St. Tammany Parish, Louisiana Feasibility Study

**Appendix C – Annex D - Coastal Zone
Consistency**

RE: **C20210082**, Coastal Zone Consistency
New Orleans District, Corps of Engineers (COE)
Direct Federal Action
Notice of Availability, *St Tammany Parish Louisiana Feasibility Study*
St. Tammany Parish, Louisiana

Draft Integrated Feasibility Report and Environmental Impact Statement for the St. Tammany Parish Louisiana, Feasibility Study St. Tammany Parishes, Louisiana

Figure 7. Optimized TSP for the West Slidell and the South Slidell Levee and Floodwall System

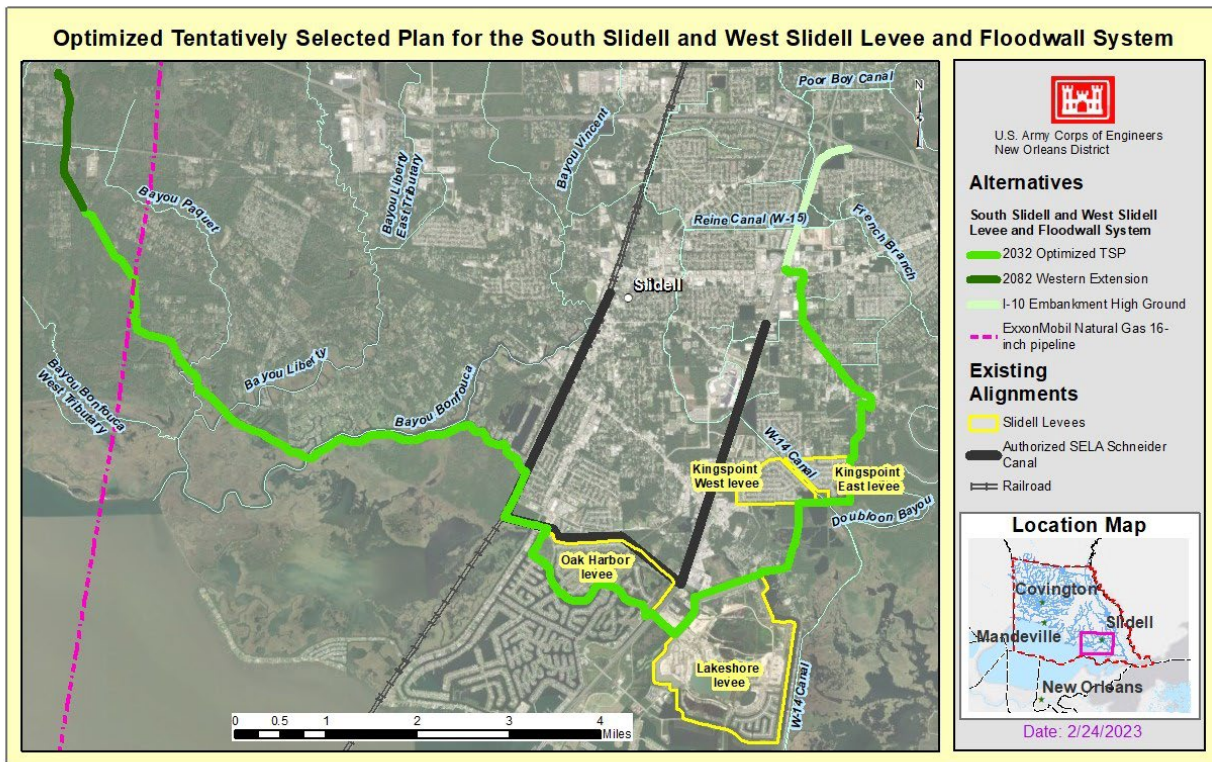
- As described, the Tentatively Selected Plan will directly impact approximately 157 acres, and indirectly impact approximately 1,707 acres, of marsh, swamp, and Bottomland Hardwood habitat. In several areas the tentatively selected levee alignment crosses or encloses wetlands. The Coastal Use Guidelines at §703 includes the following:

- B. Levees shall be planned and sited to avoid segmentation of wetland areas and systems to the maximum extent practicable.
- D. Hurricane and flood protection levees shall be located at the nonwetland/wetland interface or landward to the maximum extent practicable.
- F. Hurricane or flood protection levee systems shall be designed, built and thereafter operated and maintained utilizing best practical techniques to minimize disruptions of existing hydrologic patterns, and the interchange of water, beneficial nutrients, and aquatic organisms between enclosed wetlands and those outside the levee system.

OCM recommends that every effort be made to select a levee alignment that minimizes impacts to, or impoundment of, coastal wetlands.

Response: Concur. Measures were taken to avoid to the maximum extent possible impacts to wetlands and then modify impacts to wetlands to the greatest degree possible and still meet the project purpose. The proposed Optimized TSP represents the least environmentally damaging alternative. None the less , there are unavoidable impacts to wetlands resulting from construction and implementation from the project. A compensatory mitigation plan has been developed and is attached for your reference.

Response: Concur. Measures were taken to avoid and minimize to the greatest extent possible segmenting wetland systems in developing the proposed Optimized TSP levee alignment. However, some wetlands and systems will be segmented. A compensatory mitigation plan has been developed and is attached for your reference. The mitigation plan was developed and shared with the habitat evaluation team.

Figure 31. Optimized Mile Branch Channel Improvements

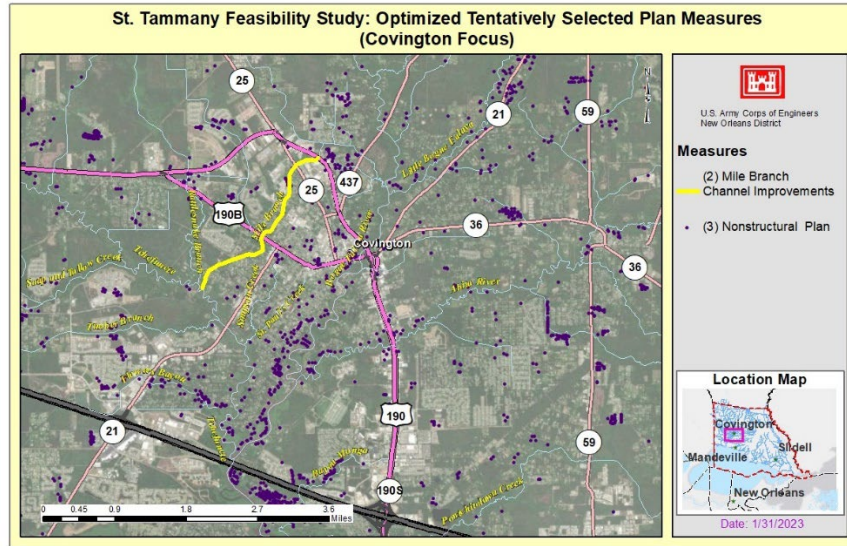
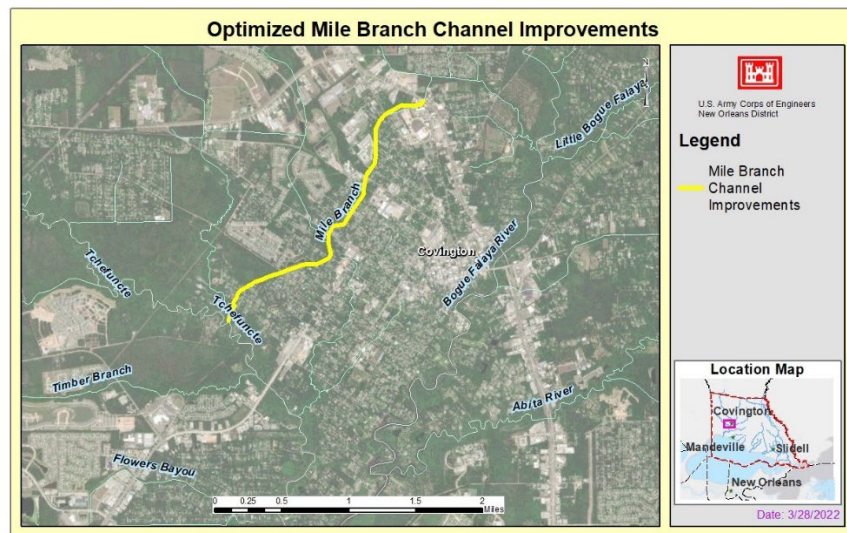
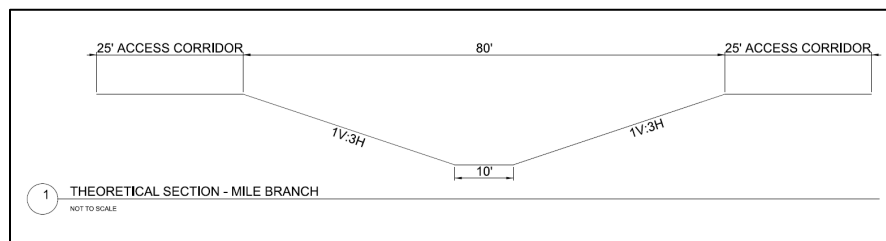
- Clearing and dredging operations are proposed for Mile Branch. This is a designated Scenic Stream; authorization from the Louisiana Department of Wildlife and Fisheries will be required. Further, the proposed disposal of up to 130,000 yd³ of material dredged from the channel is sidecast along the bank, or hauled off site. Coastal Use Guideline §707 states:

As planning proceeds, opportunities for beneficial use of this dredged material should be incorporated into the project wherever possible.

Response: Dredged spoil for the bypass channels would be stockpiled adjacent to the bypass channel and utilized for backfilling of the channel when construction is complete. There is no beneficial use of dredge material planned. While Mile Branch is not in the coastal zone, dredged material from the channel improvements would be disposed at an approved landfill.

Response: Spoil from the Mile Branch channel improvements shall be placed at an approved landfill. Spoil from the construction of bypass channels would be stockpiled in a manner that would reduce impacts to wetlands. The stockpiled material would be utilized to restore the channel once construction was complete.
